# Security and CPTED Report

Project Reference: 896 Woodville Road,  
Villawood

Report Ref: 390910-896-Woodville-Rd-CPTED-Report-RevA

## Annex A – CPTED Mark-up of Architectural Plans

**B3 FLOOR PLAN**

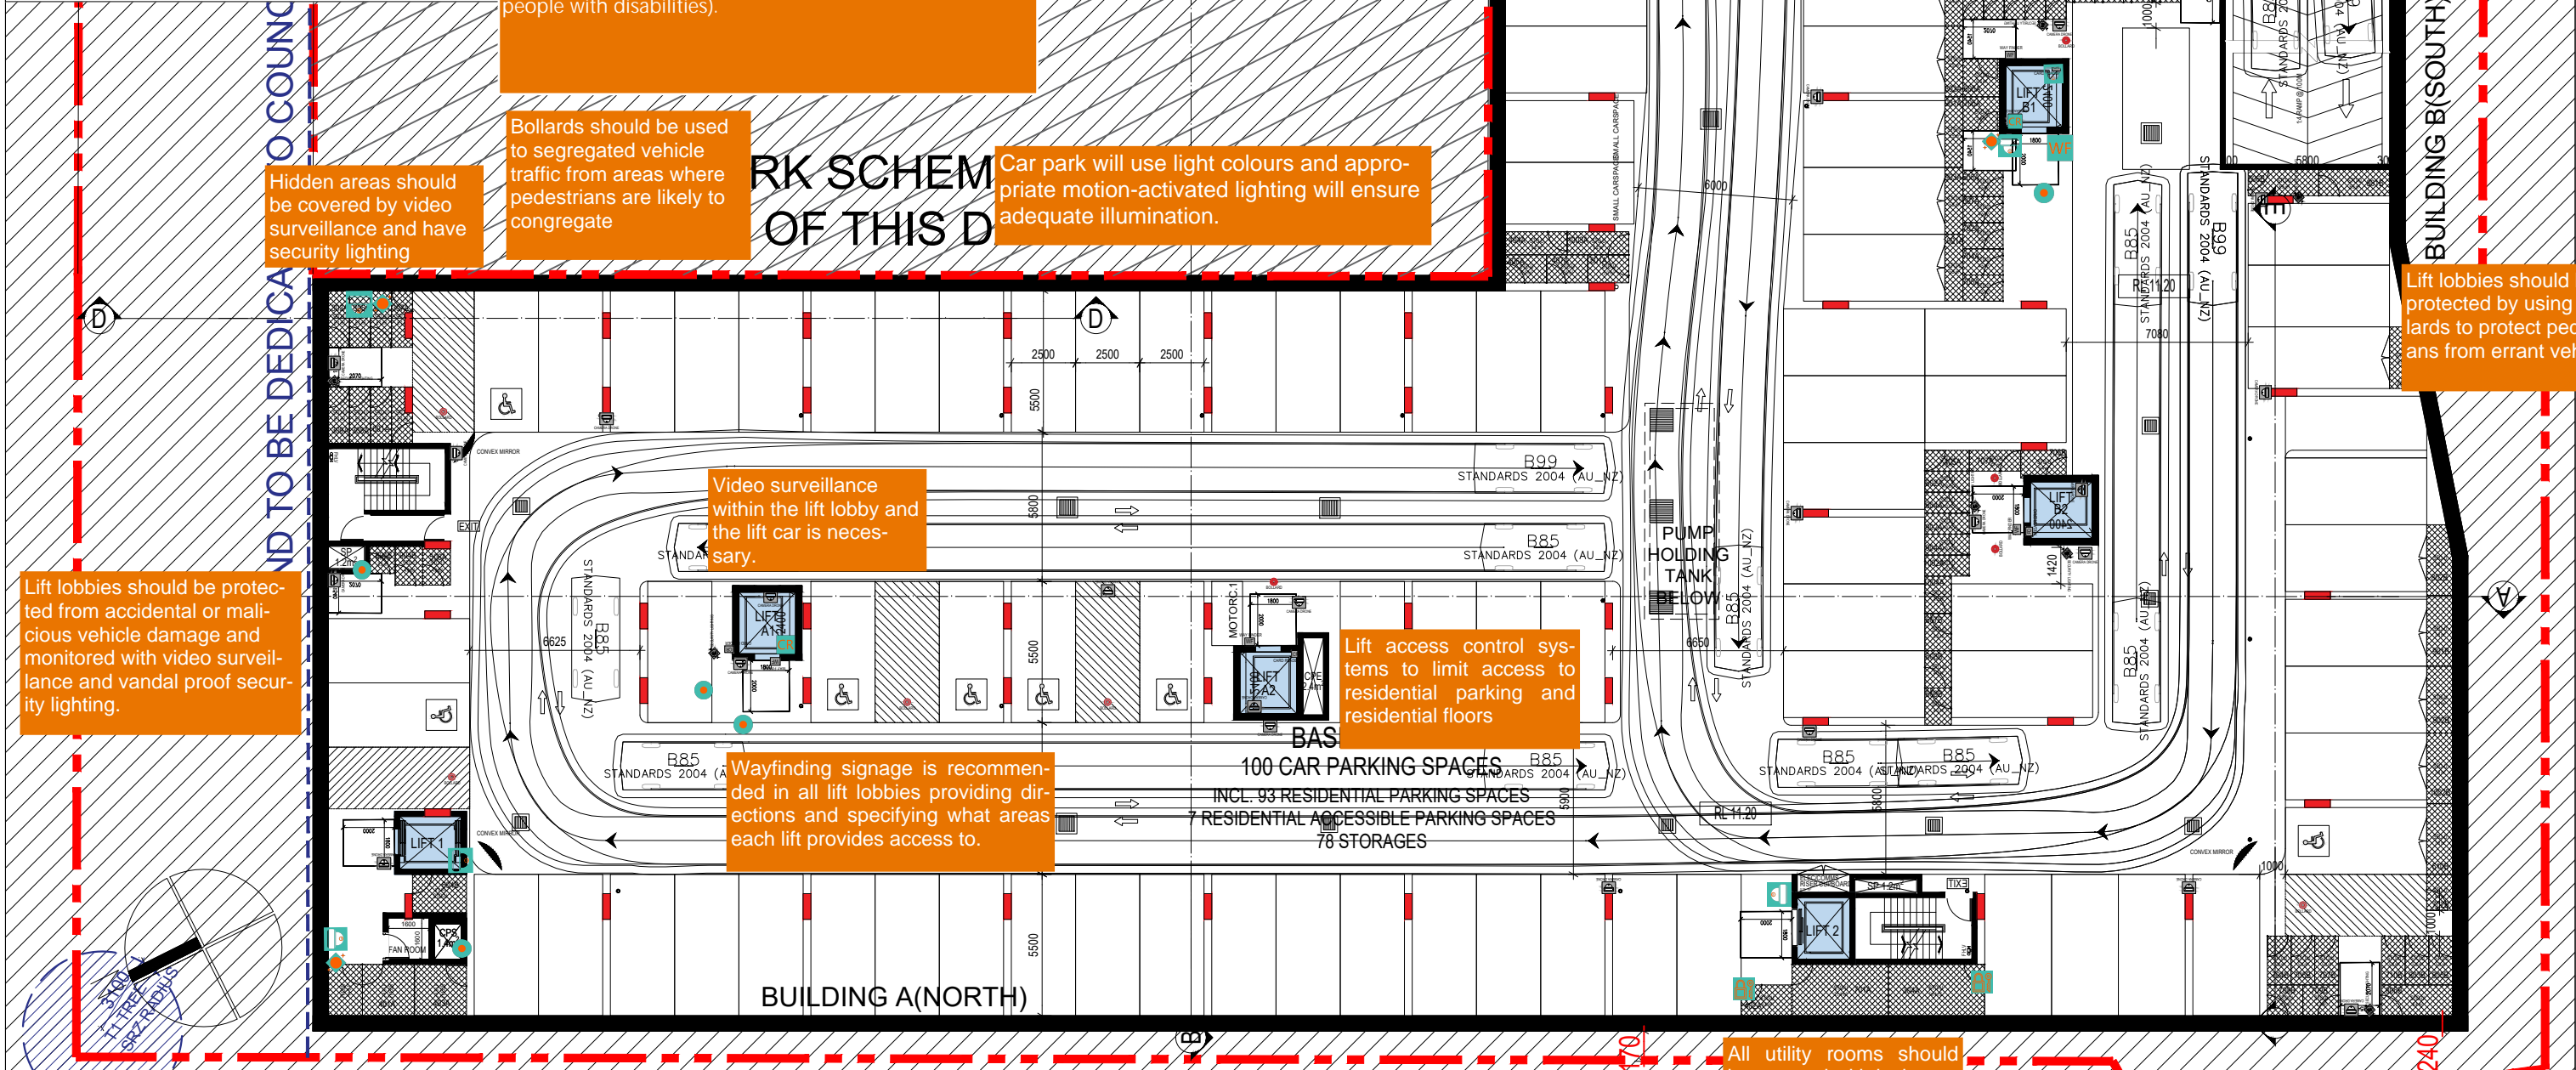
Wayfinding signage is recommended in all lift lobbies providing directions and specifying what areas each lift provides access to.

Lift access control systems to limit access to residential parking and residential floors

All utility rooms should be secured with locks

Video surveillance coverage of the basement car park area is recommended.

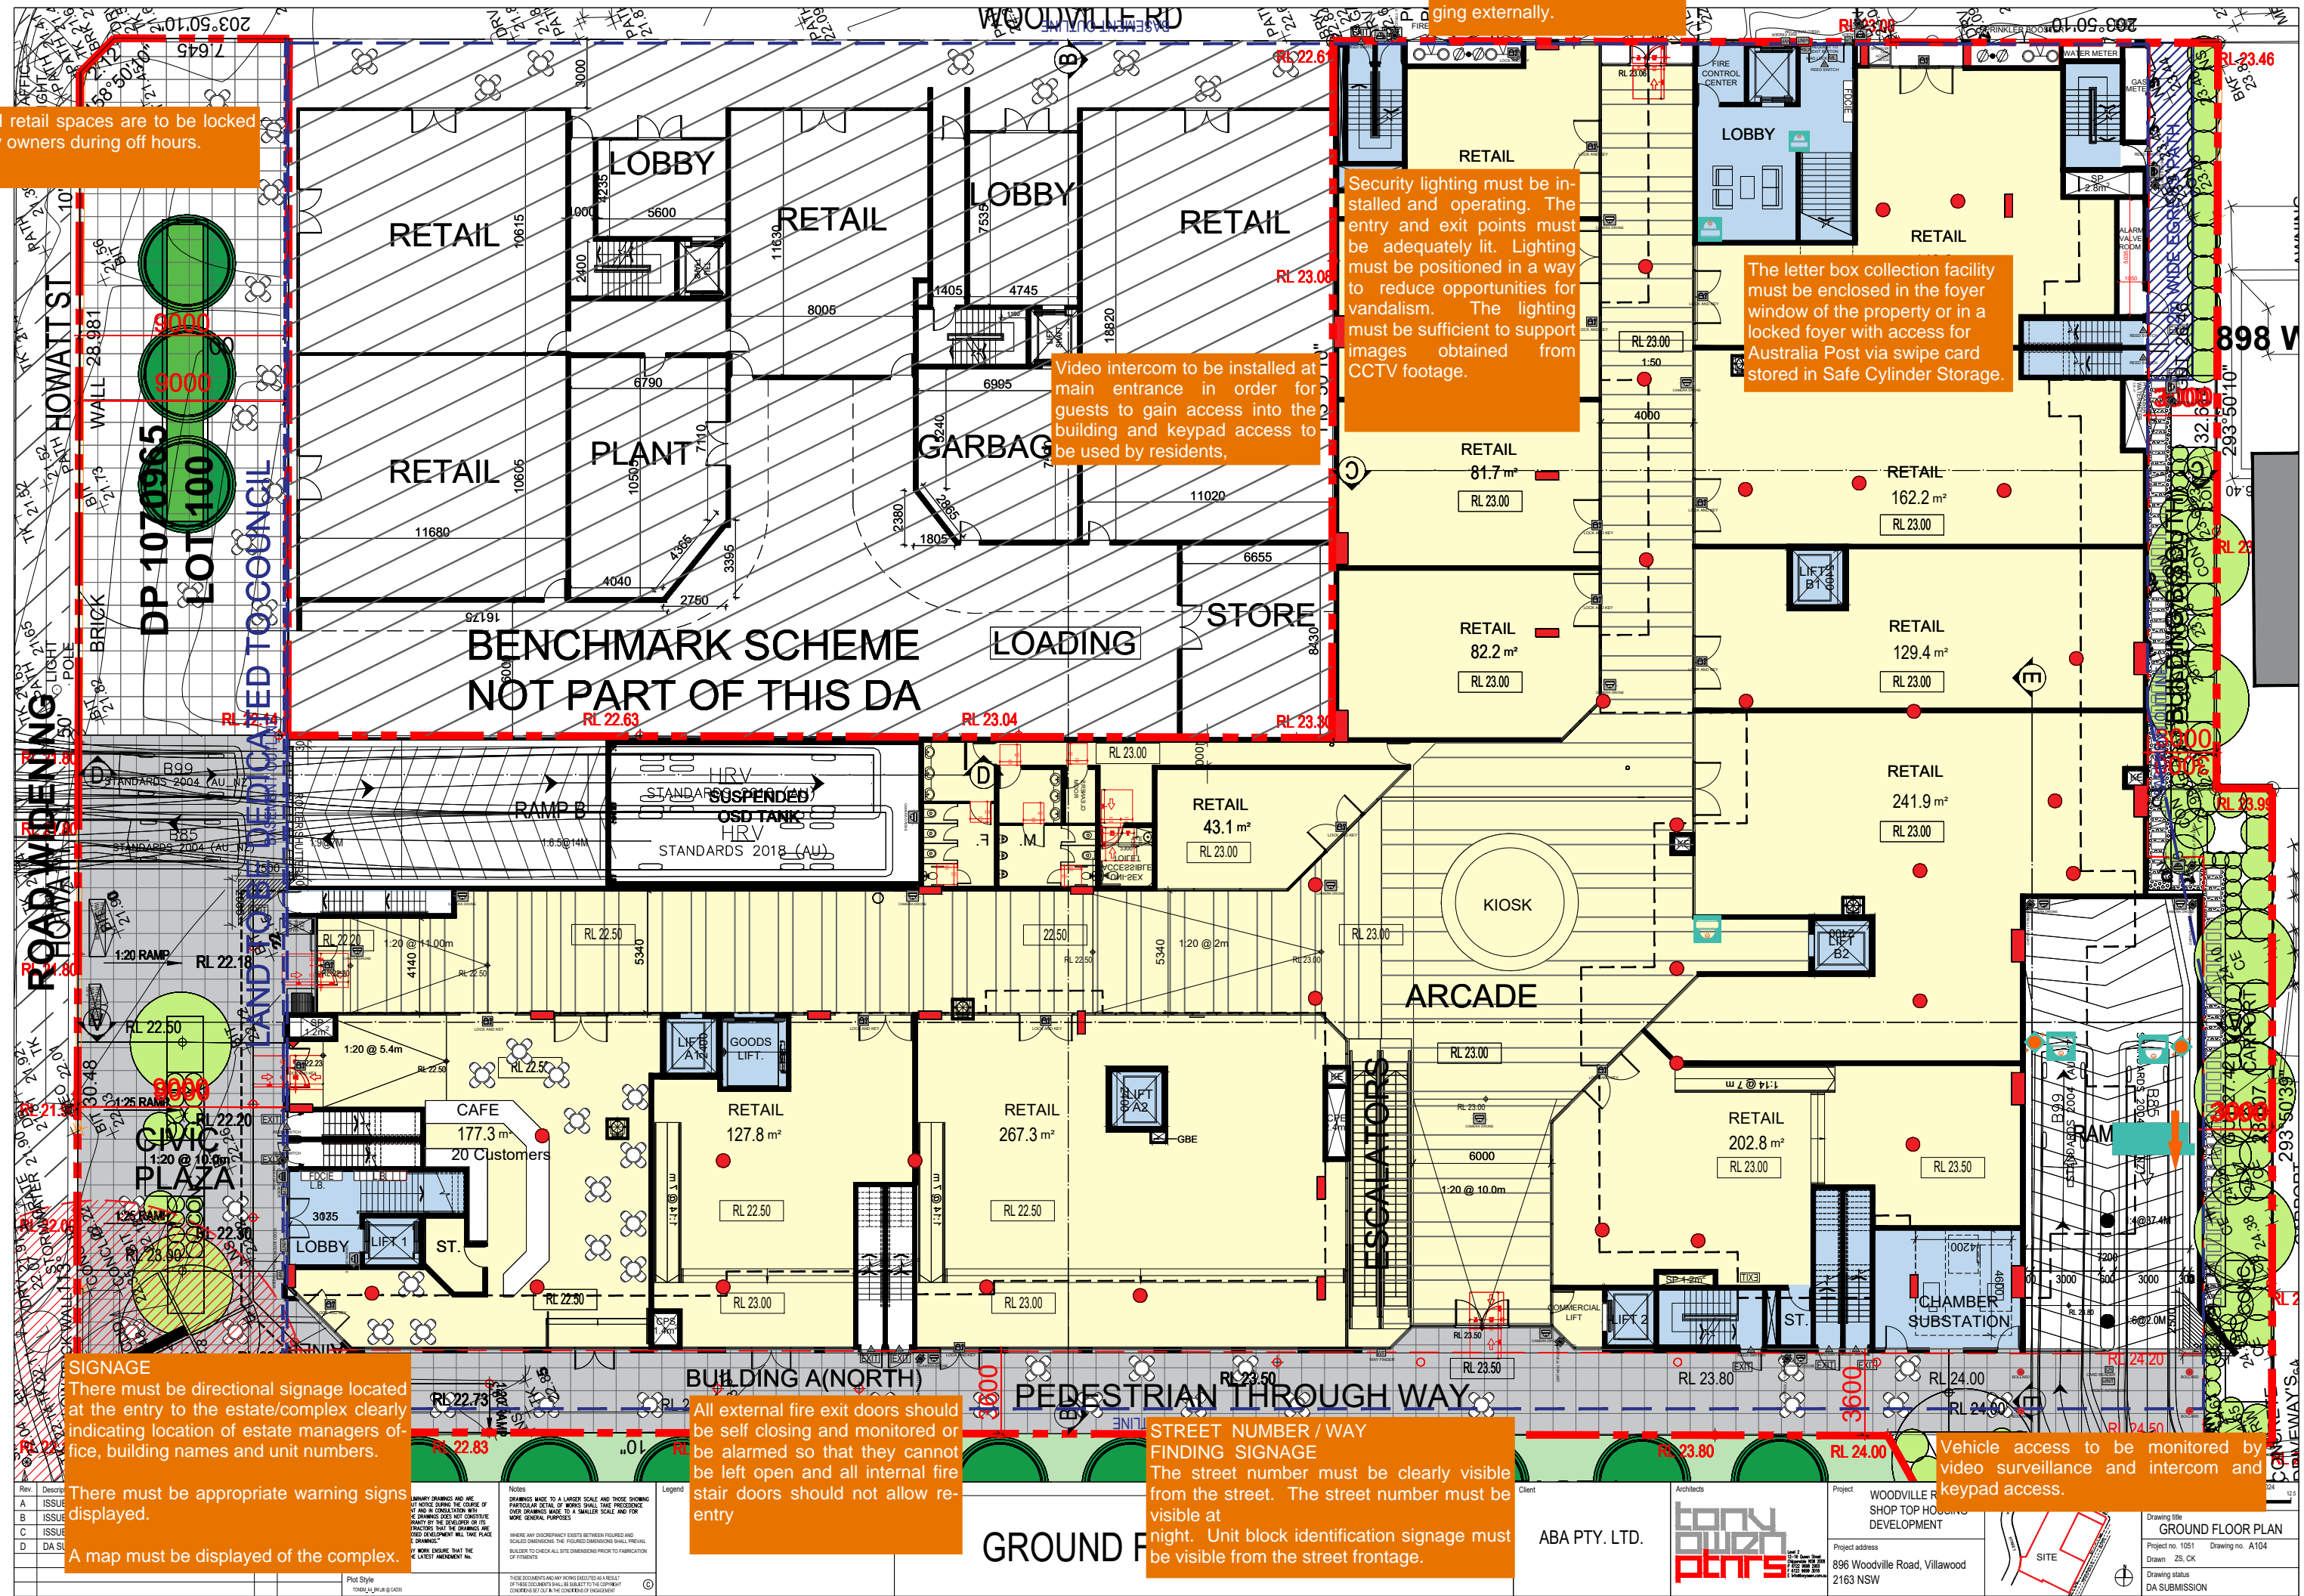
The letter box collection facility must be enclosed in the foyer window of the property or in a locked foyer with access for Australia Post via swipe card stored in Safe Cylinder Storage.

**SIGNAGE**  
There must be directional signage located at the entry to the estate/complex clearly indicating location of estate managers office, building names and unit numbers.

There must be appropriate warning signs displayed.

A map must be displayed of the complex.

Vehicle access to be monitored by video surveillance and intercom and keypad access.
